# METROPOLITAN GOVERNMENT OF NASHVILLE AND DAVIDSON COUNTY

## STAFF RECOMMENDATION 3814 Richland Avenue November 19, 2014

**Application:** New construction-addition  
**District:** Richland-West End Neighborhood Conservation Zoning Overlay  
**Council District:** 24  
**Map and Parcel Number:** 10409004100  
**Applicant:** Manuel Zeitlin Architects  
**Project Lead:** Paul Hoffman, [paul.hoffman@nashville.gov](mailto:paul.hoffman@nashville.gov)

**Description of Project:** The application is for addition of a two-story screened porch and deck to the rear and side of the house; the addition will extend beyond the side wall of the house.

Figure 1. 3814 Richland Avenue

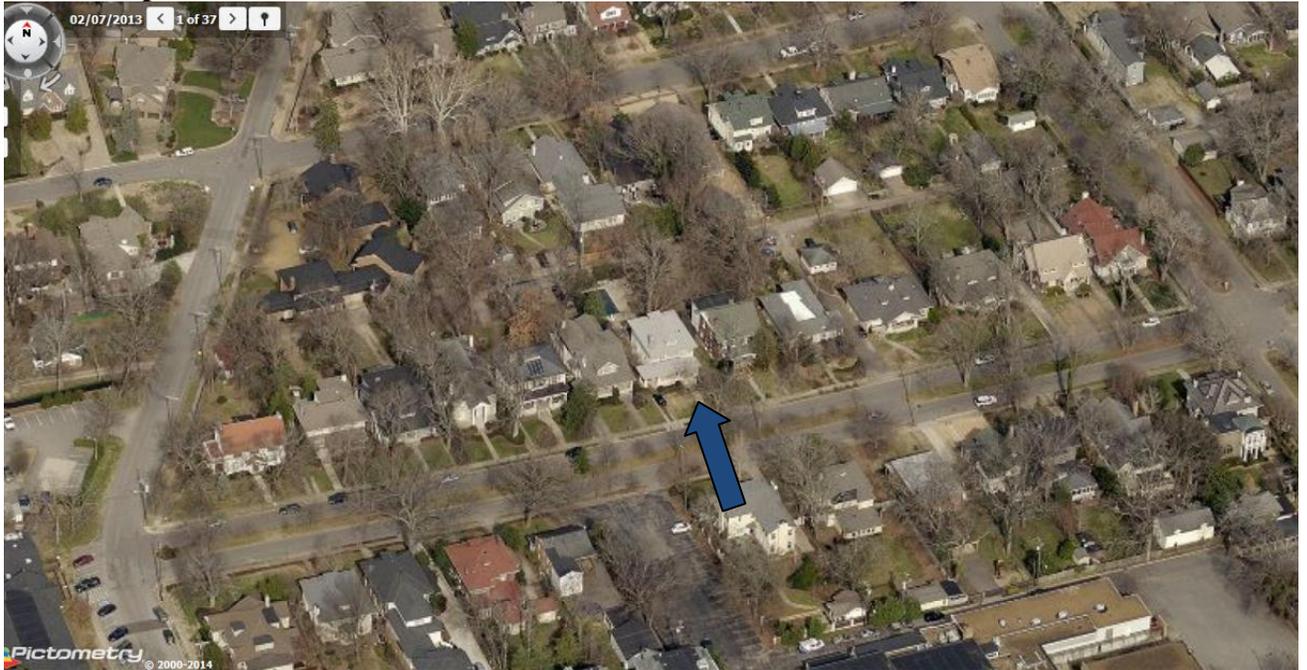
**Background:** 3814 Richland Avenue is a four-square home built circa 1915, and is a contributing building to the Richland-West End Neighborhood Conservation Zoning Overlay.

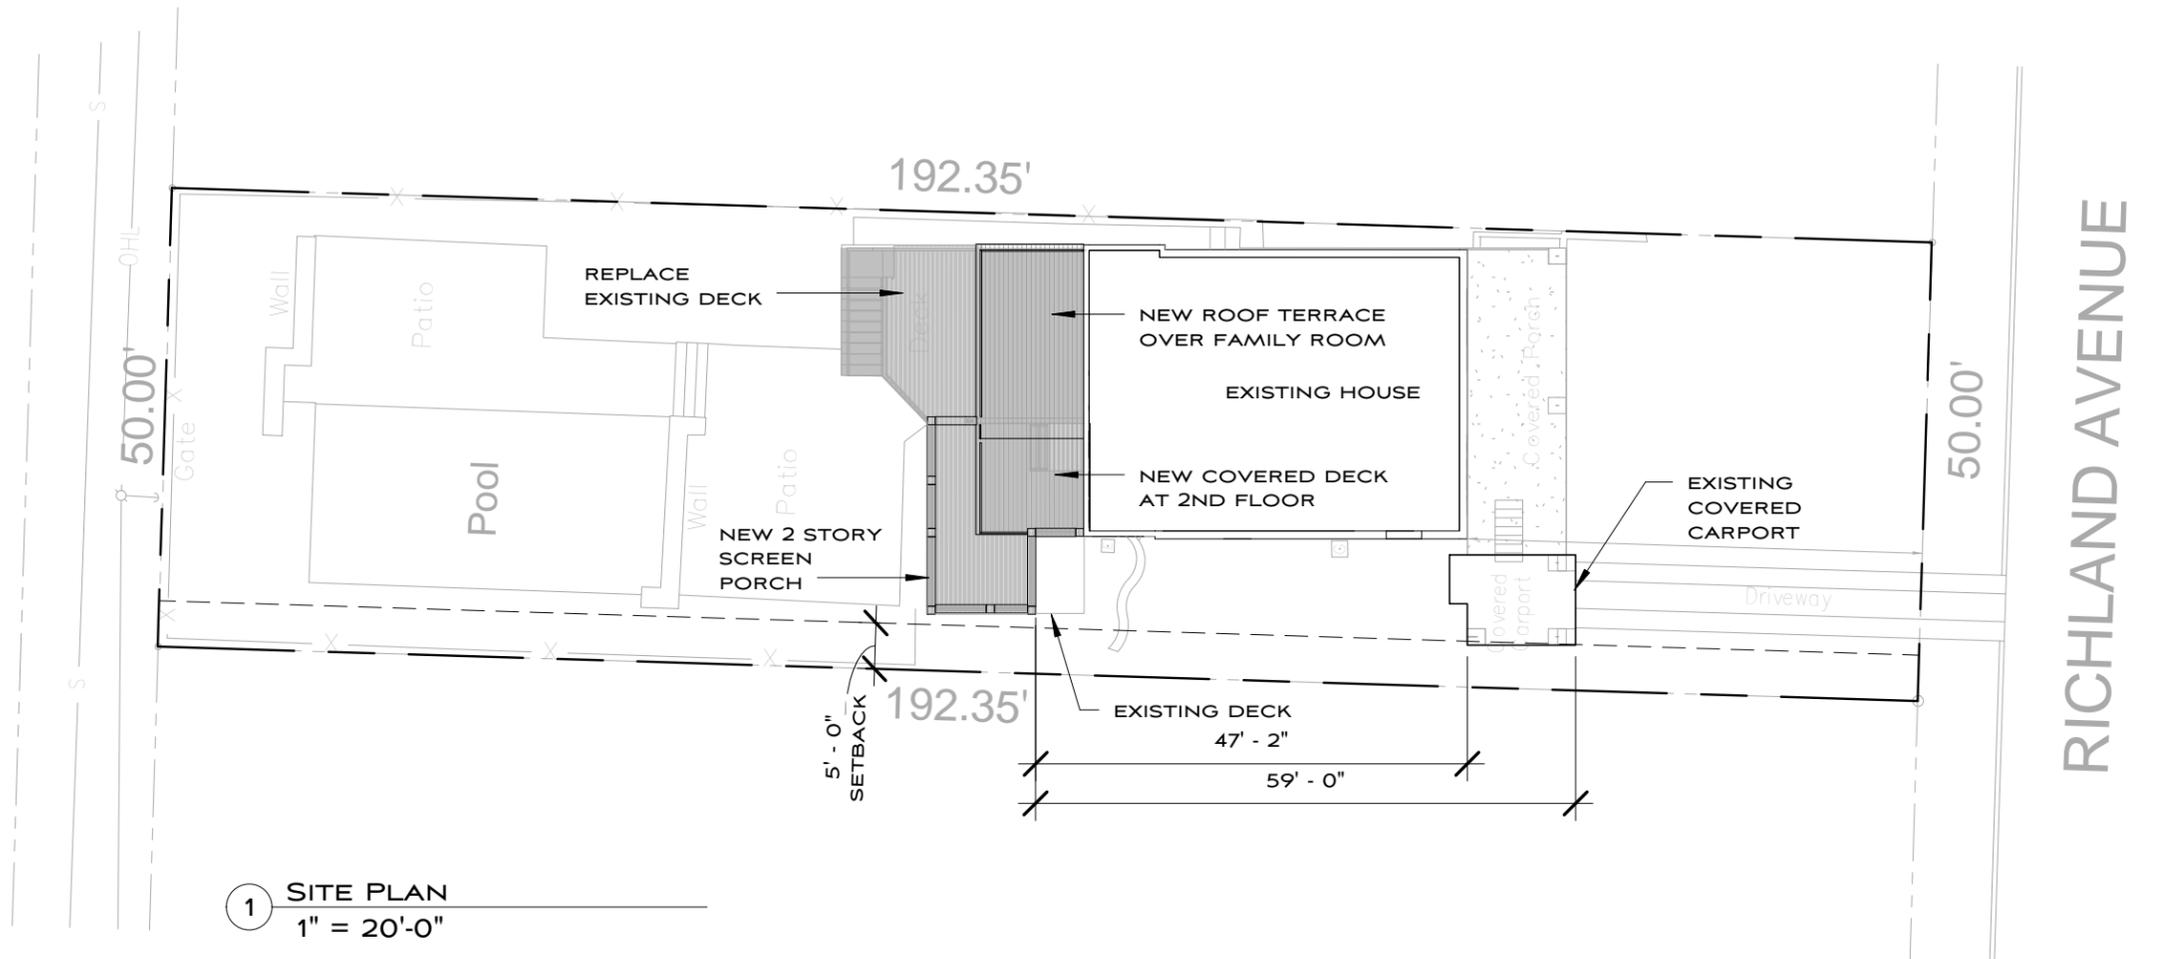
Proportion and Rhythm of Openings: Several window openings inside the proposed porch area will be replaced with framing and new doors opening into the screened porch. As these windows are in a rear porch enclosed at an unknown date, staff finds the proposed proportion and rhythm of openings to meet Section II.B.1.g.
